## **BCA REPORT – EXTENSION TO AN EXISTING CHILD CARE CENTRE**

My Early Learning Centre – Earlwood

20 Earlwood Avenue, Earlwood, NSW 2206)

<b>PREPARED FOR</b>	Joe Loufty Vogue Building Service Pty Ltd
<b>REVISION NUMBER</b>	02
<b>DATE</b>	17/02/2022
<b>CERTIS REFERENCE</b>	7450
<b>PREPARED BY</b>	M Anisur Rahman
<b>TELEPHONE</b>	1300 702 085

**PROPOSED GROUND FLOOR  
ENTRANCE LOBBY MODIFICATION**

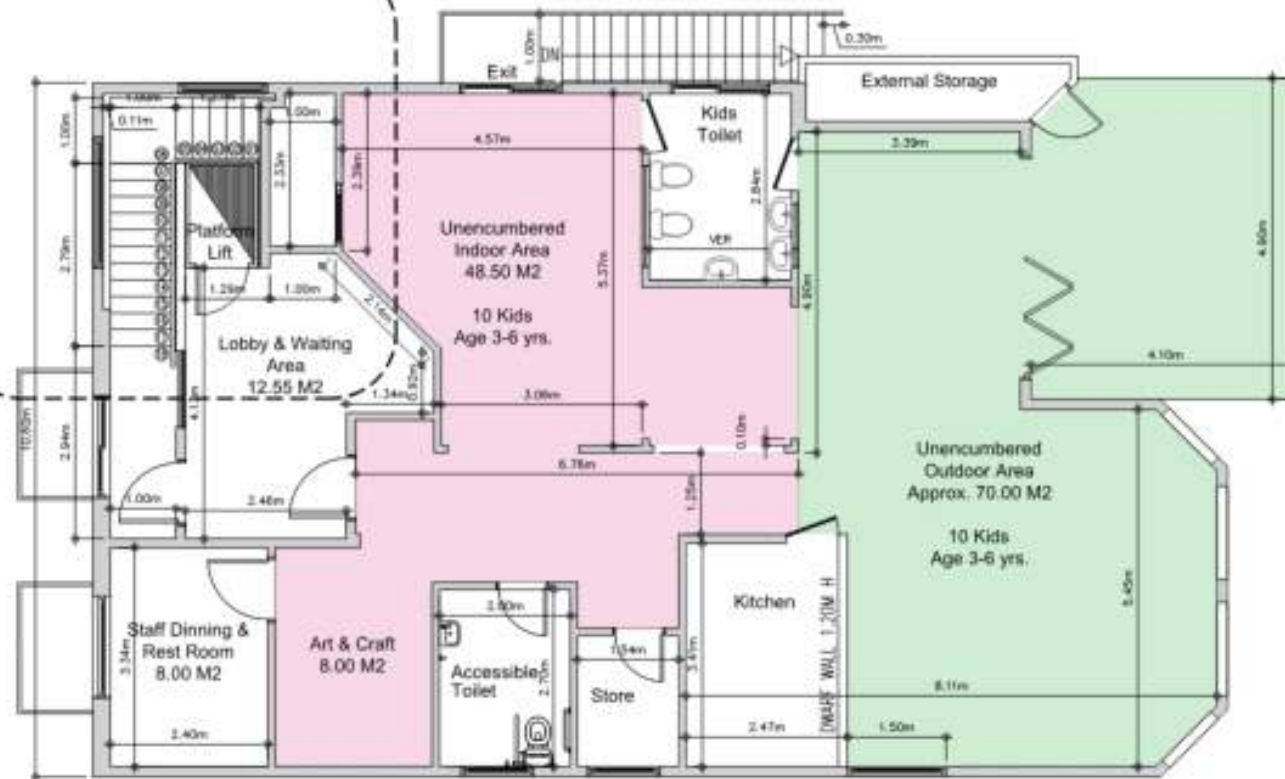
Clause	Comment/Information required by Building Surveyor	Status
D2.16	<b>Balustrades and other barriers:</b> Balustrades shown on the plans are not dimensioned but they scale off at 1000mm.	Capable of Complying
D2.17	<b>Handrails:</b> With the change in use, the stair is now required to comply with AS1428.1 and the handrail would need the “ram’s horn” terminations. That would interfere with the circulation space for the doors. Therefore, this will need to be addressed by a performance solution from an access consultant.	Performance Solution
D2.19	<b>Doorways and doors:</b>	Complies
D2.20	<b>Swinging doors:</b> Existing entry door opens outwards.	Complies
D2.21	<b>Operation of latch:</b> The existing front door has a lever handle.	Complies
D2.24	<b>Protection of openable windows:</b> All window openings must be provided with protection, if the floor below the window is 2 m or more above the surface beneath for early childhood centre in accordance with Clause D2.24.	Capable of Complying

<b>Part D3 – Access for People with a Disability</b>		
D3.1	<b>General building access requirements:</b> An early childhood centre must be accessible	Capable of Complying
D3.2	<b>Access to buildings:</b> Some of the existing doorways have insufficient circulation space (eg: the door from the entry lobby to the childcare centre). This would need to be addressed by an Access Consultant.  The change of use means that an accessible lift has been provided from Ground to level 1. - Complies	Performance Solution
D3.3	<b>Parts of the buildings to be accessible:</b> Any rooms that are not accessible will need to be addressed as part of the Access performance Solution.	Performance Solution
D3.5	<b>Accessible carparking:</b> No parking shown or proposed	Not applicable
D3.6	<b>Signage:</b> An accessible unisex sanitary facility requires signage	Capable of Complying
